## **IMPORTANT SAFETY RECALL – 15V-058**

# Safety Notice

# SN-614-14

SUBJECT: Platform rotate cylinder

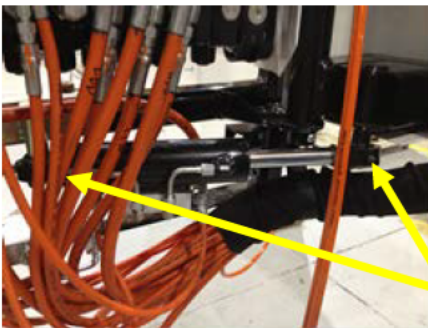
Terex has become aware that some aerial devices manufactured from July 12, 2013 through December 26, 2013 left the factory with the platform rotate cylinder bearing (e.g. ball bushing), which attaches the cylinder to the platform brackets, improperly assembled. Terex has received some reports of the cylinder slipping off the bearing and separating from the platform brackets. **If the cylinder separates from the platform brackets the operator will not have control of the platform rotate and the platform can rotate unexpectedly.** If the platform rotates without operator's control, there is an increased risk of injury.

1. Immediately inspect the platform rotation cylinder ball bushings at the boom tip on all affected machines. Verify that the ball bushing outer race is centered in the cylinder rod and base ends. The base end will be flush and the rod end will be recessed .13 inch on each side as shown in the pictures below.

2. If the ball bushing is not centered in the cylinder rod or base ends, or the ball bushing is loose in either the cylinder rod or base ends and has moved so that the ball bushing are not in the positions shown above do not operate the unit, take it out of service immediately. Contact your local Terex dealer or TEREX Utilities at 605-882-4000 or email machine information to [utilities.warranty@terex.com](mailto:utilities.warranty@terex.com) to arrange repair before further use.
3. Return the affected cylinder once the replacement cylinder has been installed.
